project: Scarborough Health Network
Mental Health Inpatient Consolidation Pod
3A3030 Birchmount Road, Scarborough, ON

ADD: 02

MMC RFQ#: CW29854
HJA project no: 24-20

date: 2026-07-03

5.1 A-200 Construction Plan – Level 3 (Pod 3A)

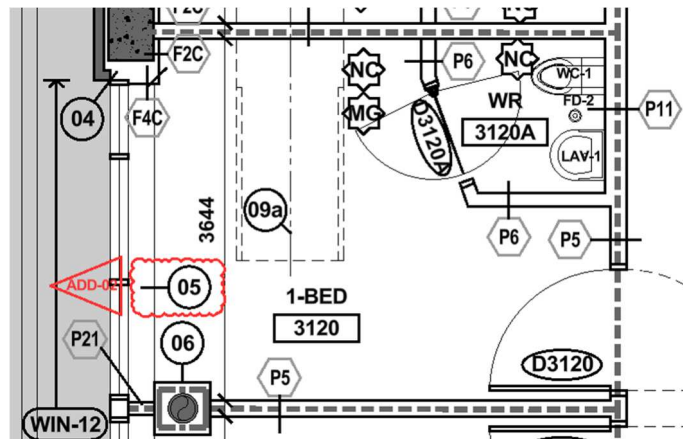
.1 **REVISED KEY NOTE** – Key note 04 on drawing 04/A-200 is updated. See sketch below.

- .2 **ADD KEY NOTE CALL OUT** – Callout for key note 5 add to room 3120. See sketch below.

Sheet Title:
PLUMBING, MEDICAL GAS AND FIRE PROTECTION NEW WORK PLAN

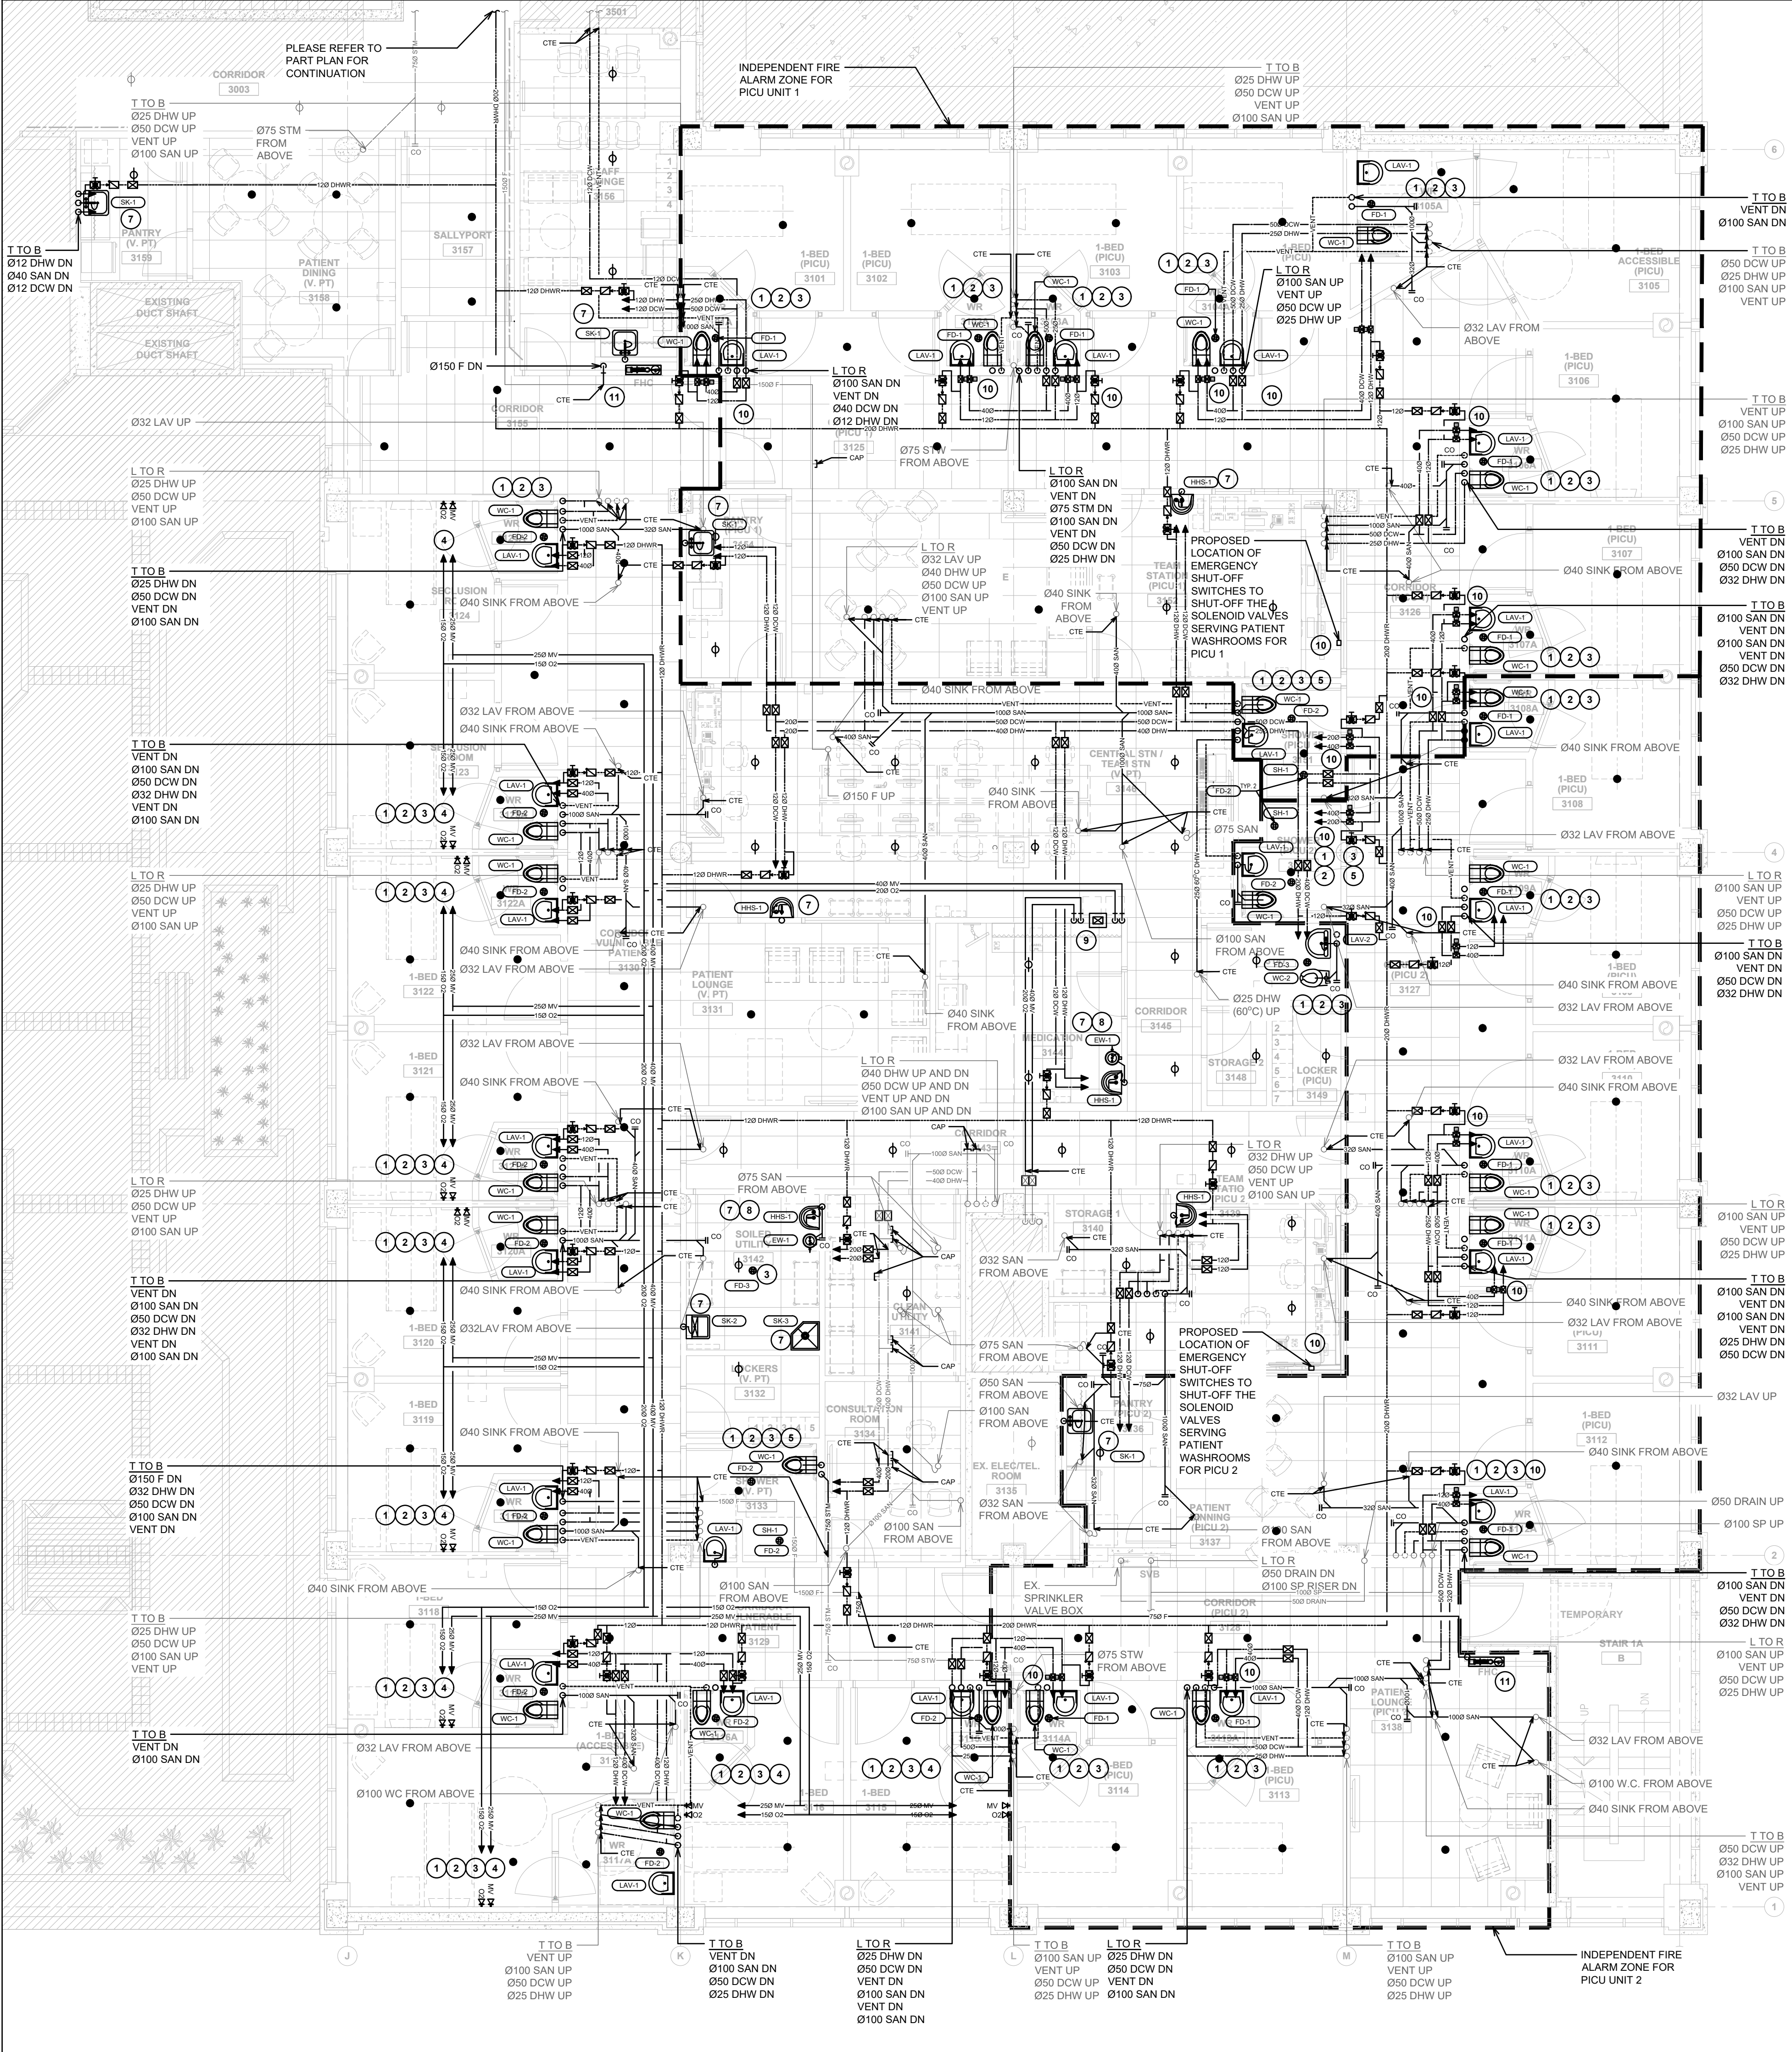
Reference	Description
M-001	1. Added base building chemical treatment contractor's information.
M-201	1. Revised mandatory base building contractor for medical gas to Class 1.
M-301	1. Added heat trace.

- PROVIDE NEW FLOOR DRAIN AS SPECIFIED. CONNECT TO EXISTING WASTE AND VENT PIPING.
 - PROVIDE NEW MEDICAL GAS OUTLETS. CONNECT TO EXISTING OXYGEN AND MEDICAL VACUUM PIPING. GAS WORK SHALL BE COMPLETED BY CLASS 1 INC.

- PROVIDE NEW EYEWASH AS SPECIFIED. CONNECT TO EXISTING DOMESTIC COLD, HOT, RECIRCULATION, WASTE AND VENT PIPING.
 - PROVIDE NEW ZONE VALVE BOX FOR MEDICAL GAS. GAS WORK SHALL BE COMPLETED BY CLASS 1 INC.
